Project	IEEE 802.16 Broadband Wireless Access Working Group < http://ieee802.org/16 >	
Title	Definitions for H-FDD mode in OFDMA	
Date Submitted	2004-11-01	
Source(s)	Yuval Lomnitz Noam Kogan Yigal Eliaspur Dov Andelman Intel.	Yuval.Lomnitz@intel.com Noam.Kogan@intel.com Yigal.Eliaspur@intel.com
	Yigal Leiba Yossi Segal Runcom Ltd.	yigall@runcom.co.il yosis@runcom.co.il
Re:	IEEE P802.16REVd/D5-2004	
Abstract	Definitions for H-FDD mode in OFDMA	
Purpose	Adopt changes.	
Notice	This document has been prepared to assist IEEE 802.16. It is offered as a basis for discussion and is not binding on the contributing individual(s) or organization(s). The material in this document is subject to change in form and content after further study. The contributor(s) reserve(s) the right to add, amend or withdraw material contained herein.	
Release	The contributor grants a free, irrevocable license to the IEEE to incorporate material contained in this contribution, and any modifications thereof, in the creation of an IEEE Standards publication; to copyright in the IEEE's name any IEEE Standards publication even though it may include portions of this contribution; and at the IEEE's sole discretion to

Figure 1 – example of efficient H-FDD operation

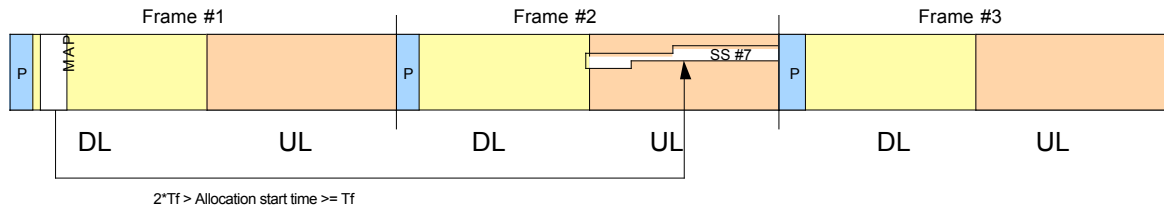
The UL map relevance is 3 frames ahead, which is similar to UL map relevance of 1 frame ahead in a TDD system with a double frame duration (see figure below).

The following figure illustrates the solution:

Figure 49a – MAP relevance for H-FDD in OFDMA PHY

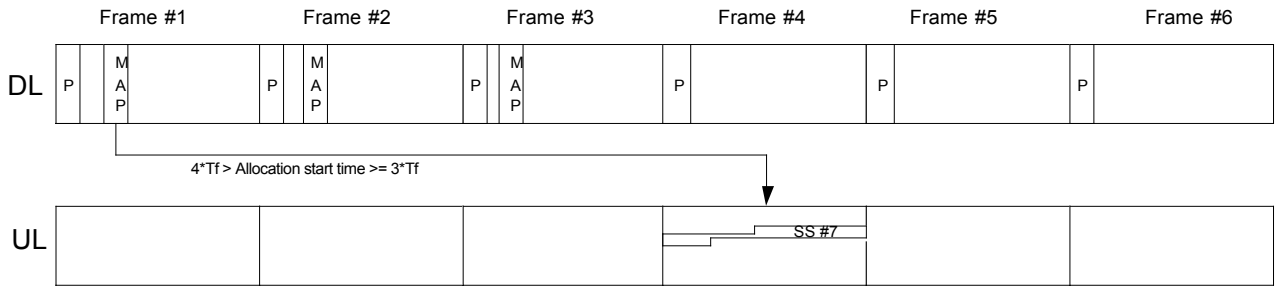
For H-FDD systems, the Allocation Start Time shall be subject to the following limitations:

- Minimum value: Allocation Start Time $\geq 3 * T_f$
- Maximum value: Allocation Start Time $< 4 * T_f$

[add figure 49a]
